MEMORANDUM

Re: **RC-19-001 – RCOZ C Special Exception for a Residence
4586 South Thousand Oaks Drive**

Applicant: **Gary and Nazeli Manukyan**

Zone: **R-1-10 / RCOZ**

40' TOPO OFFSET

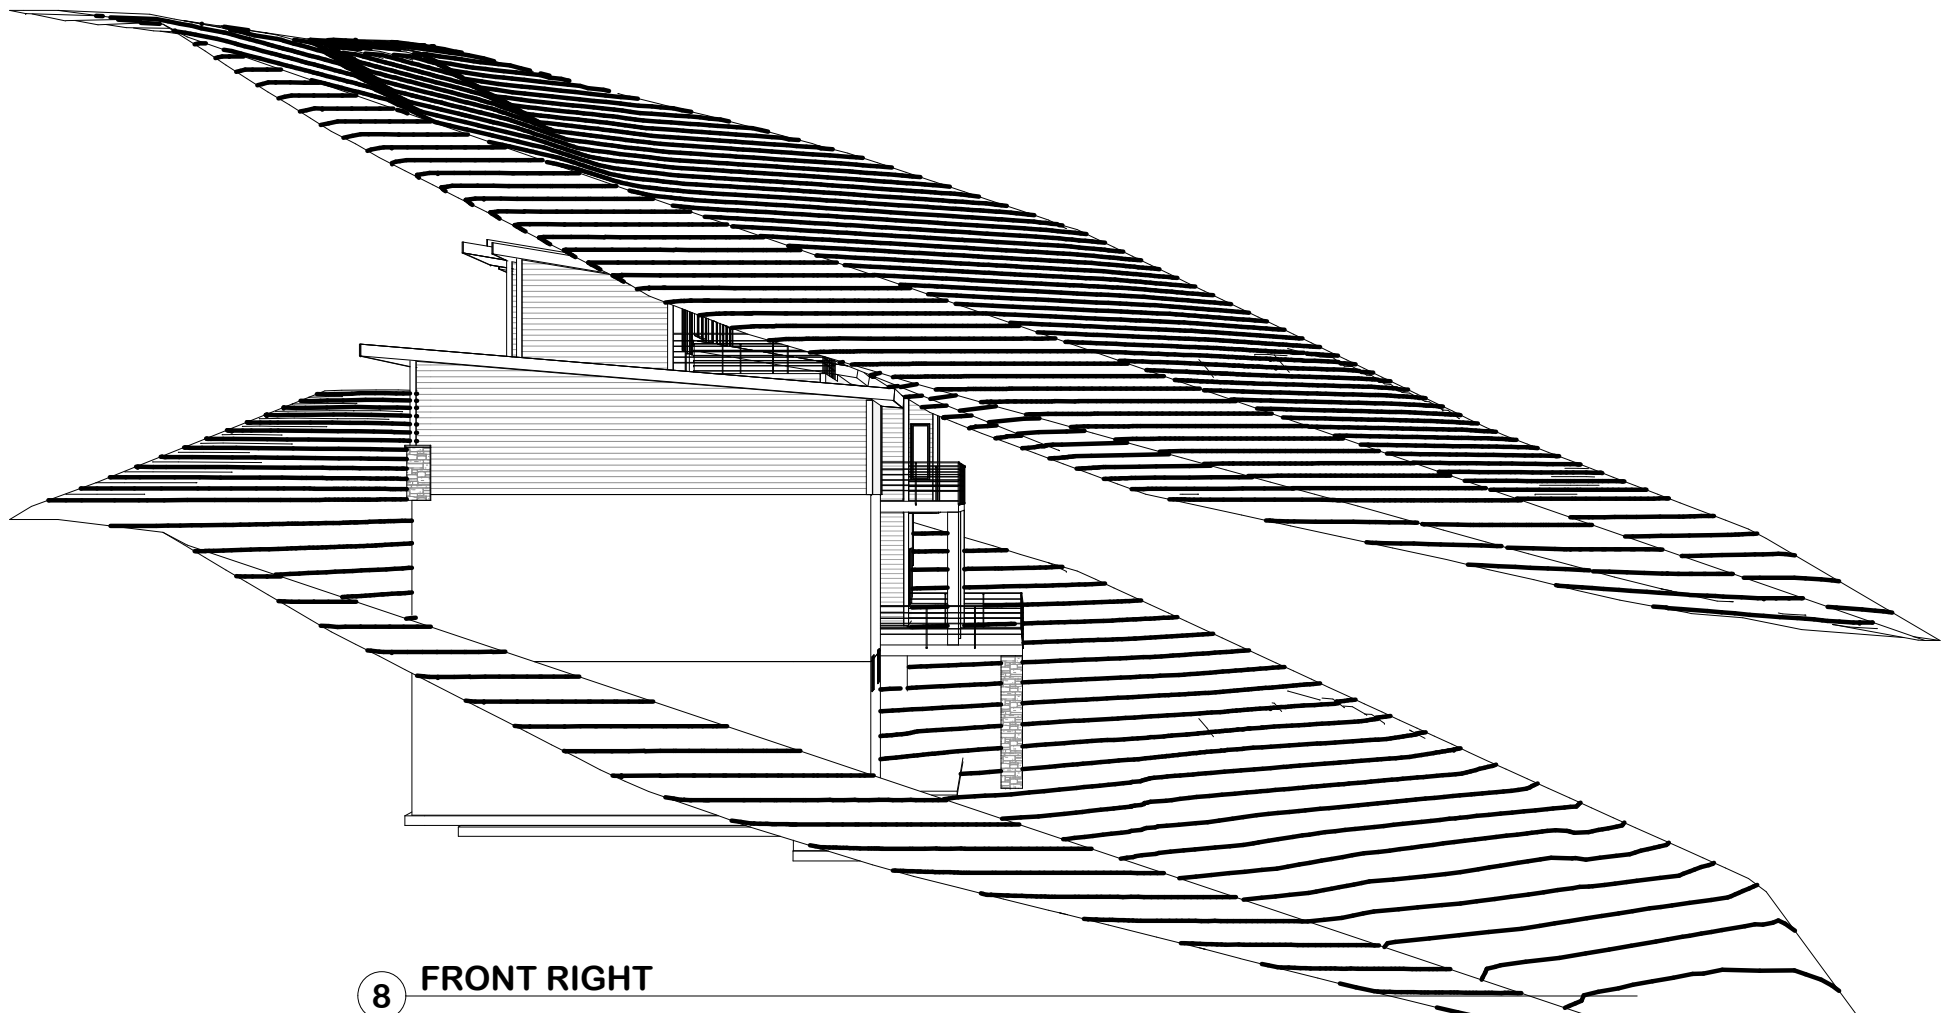
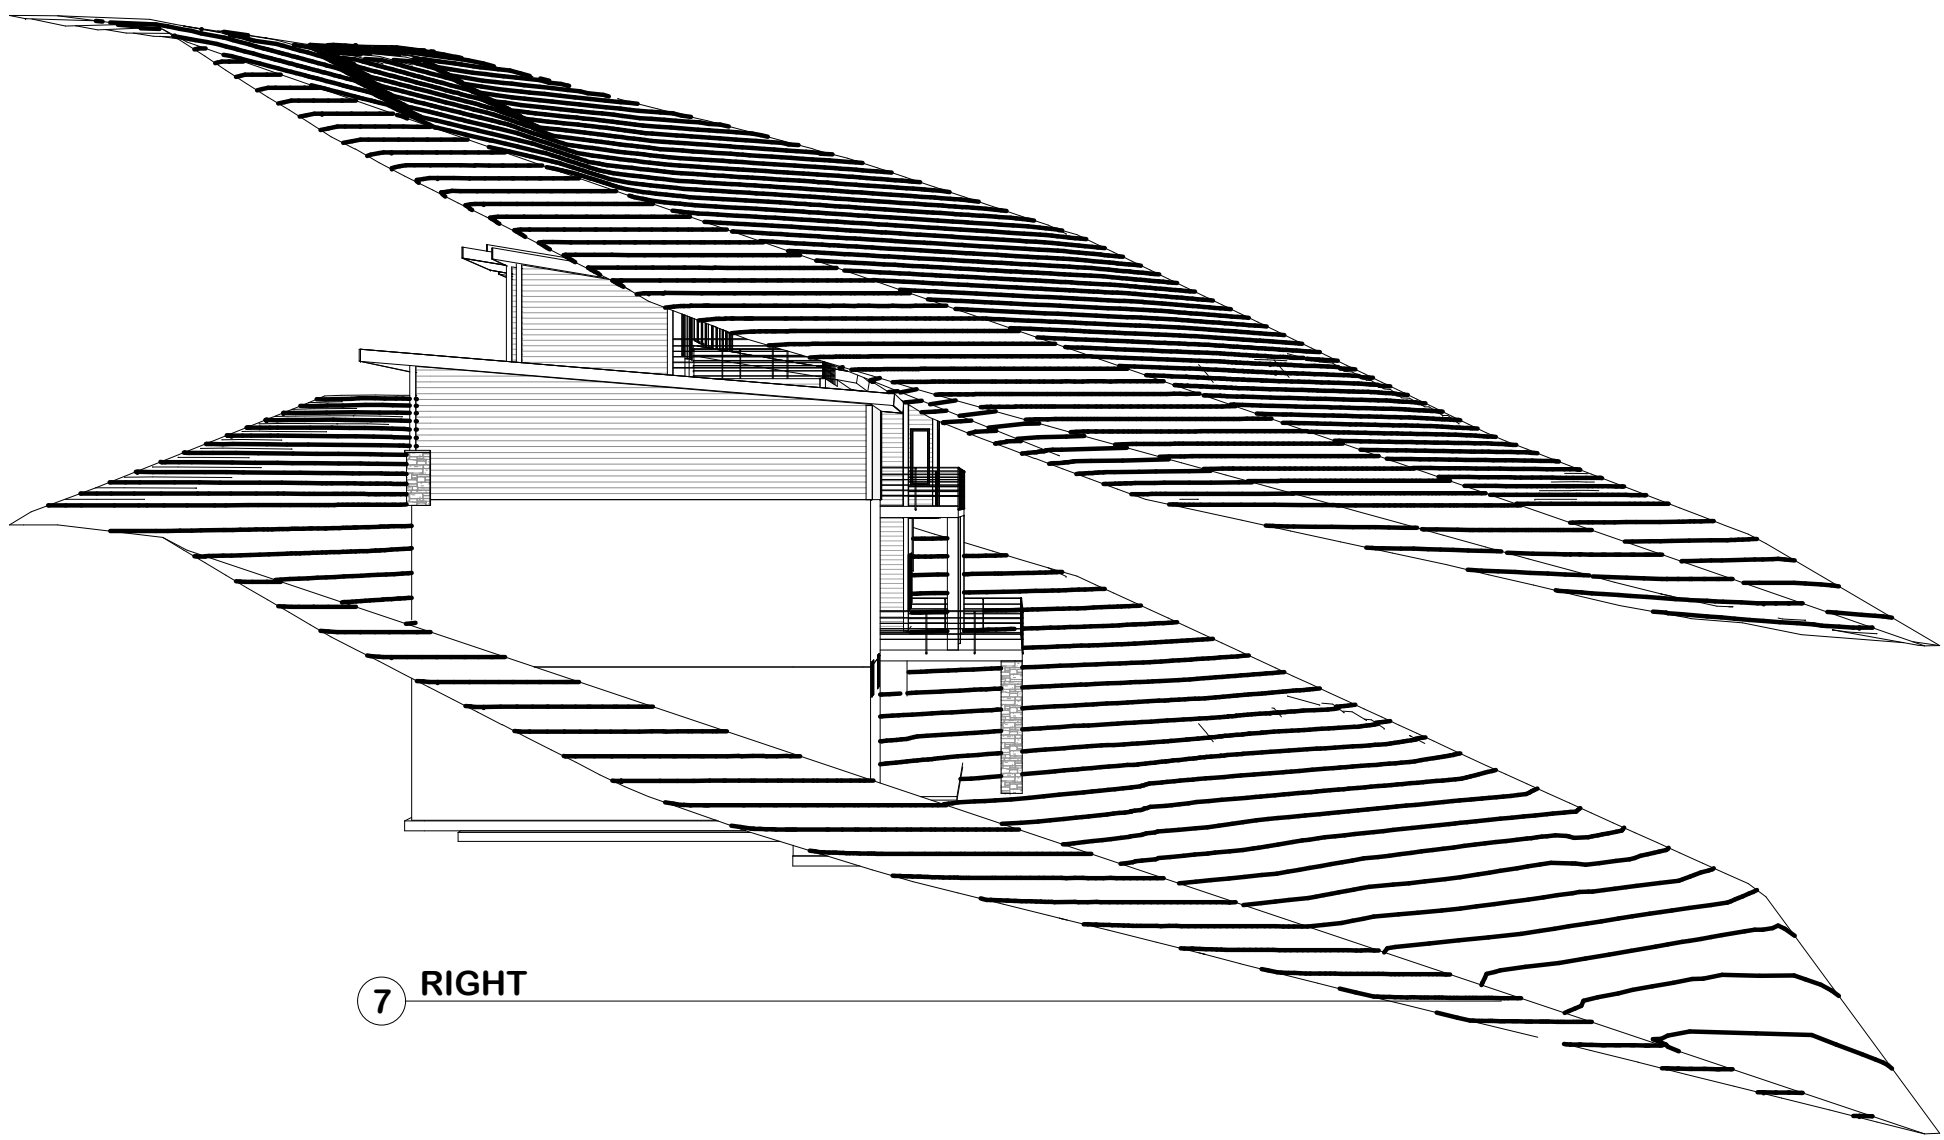
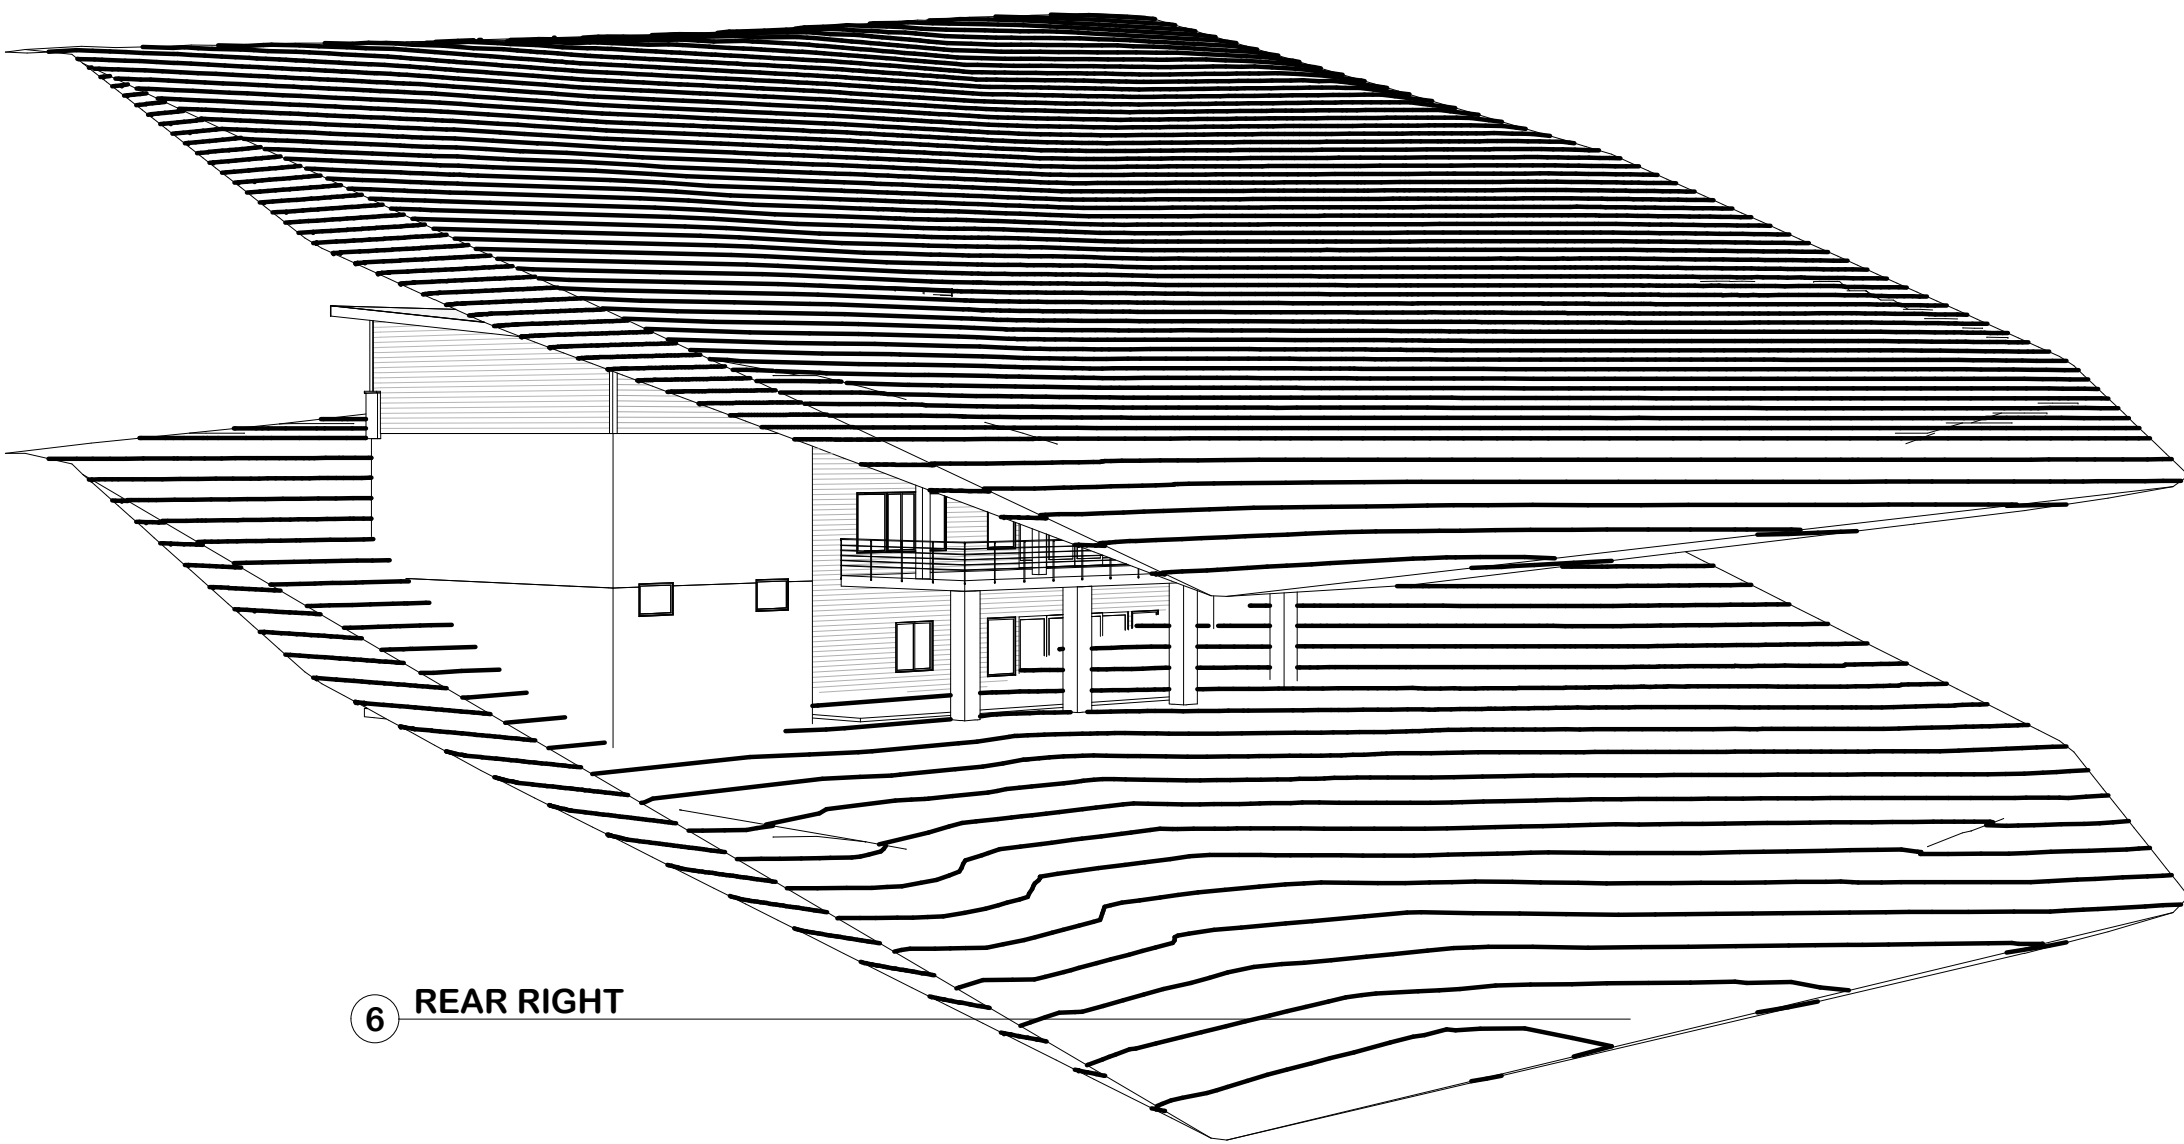
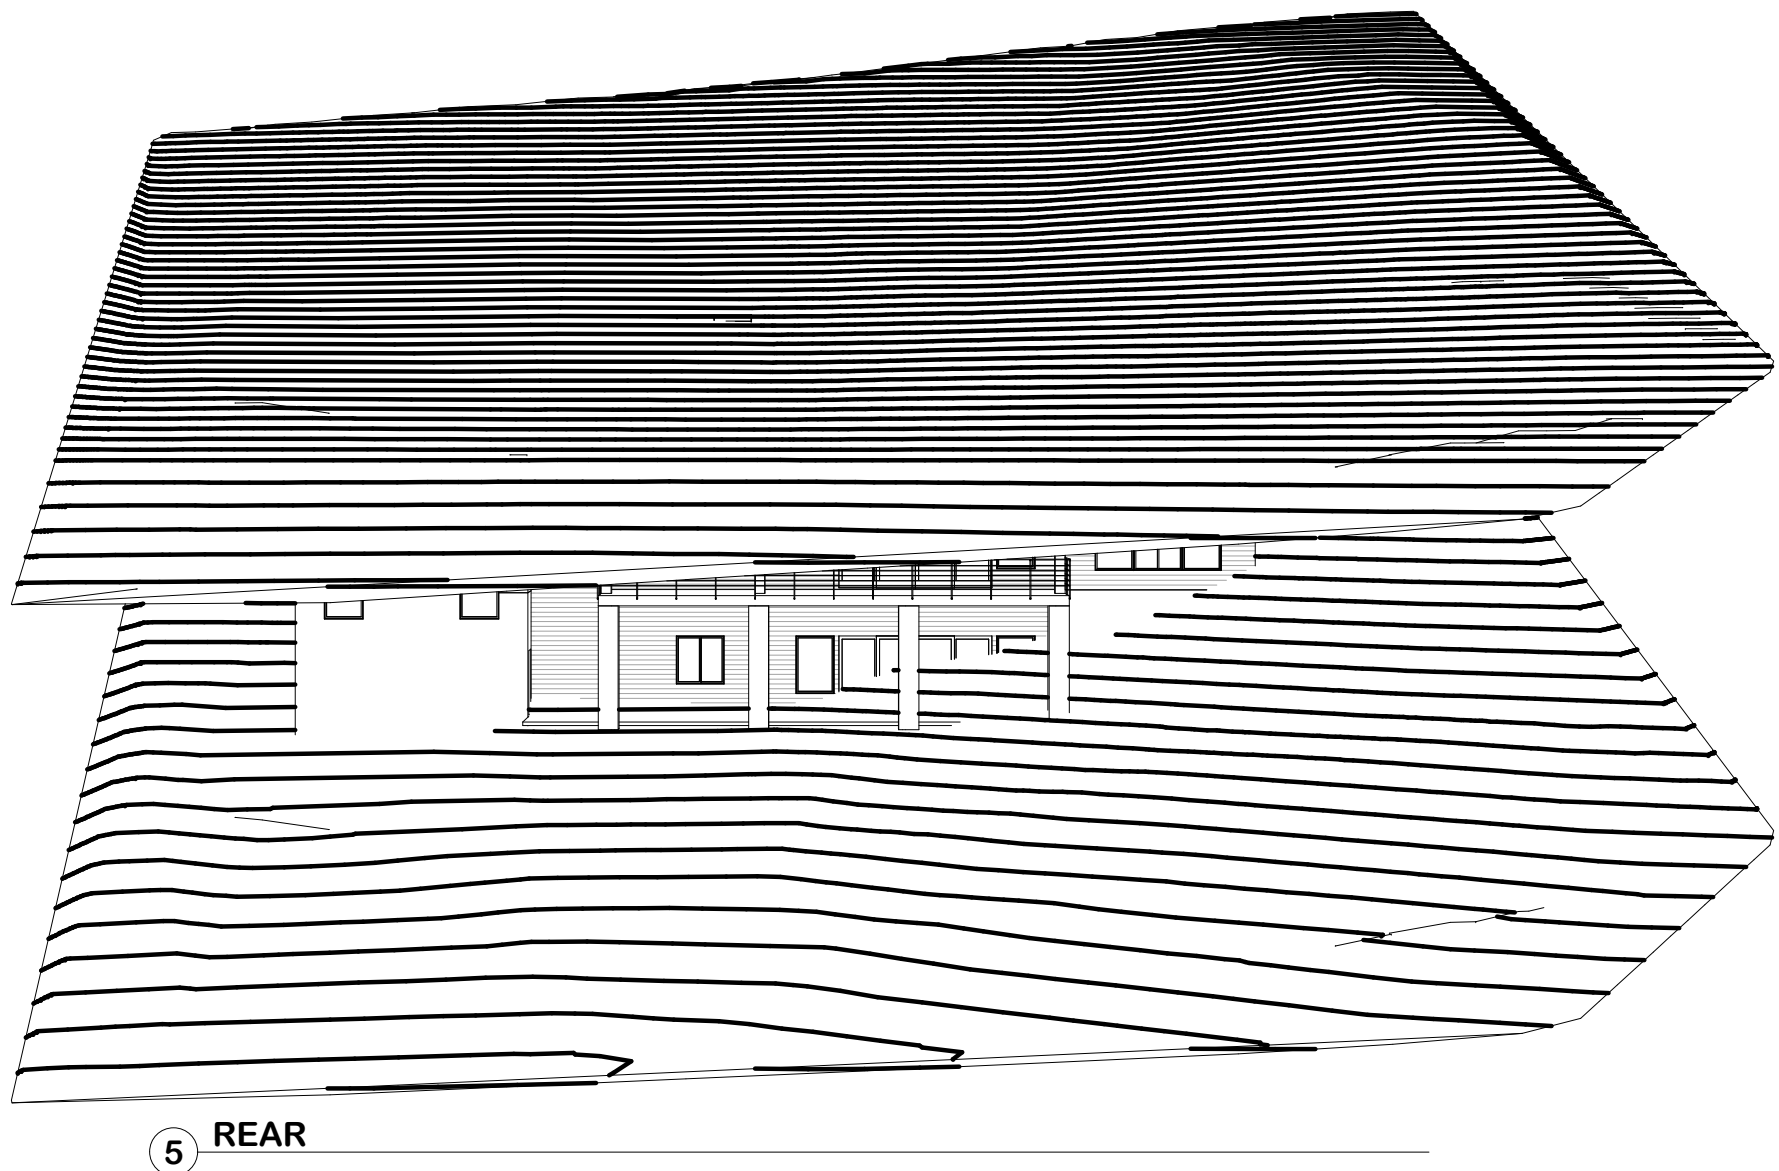
The applicant provided a topographical offset diagram that shows that no point of the home will exceed 40 feet above original grade. A portion of the rear façade, at about the midpoint of the length of the lot, is right at 40 feet – owing to the concave shape of the lot. However, much of the building falls well below the 40 foot height limit imposed by RCOZ C. See Attachment
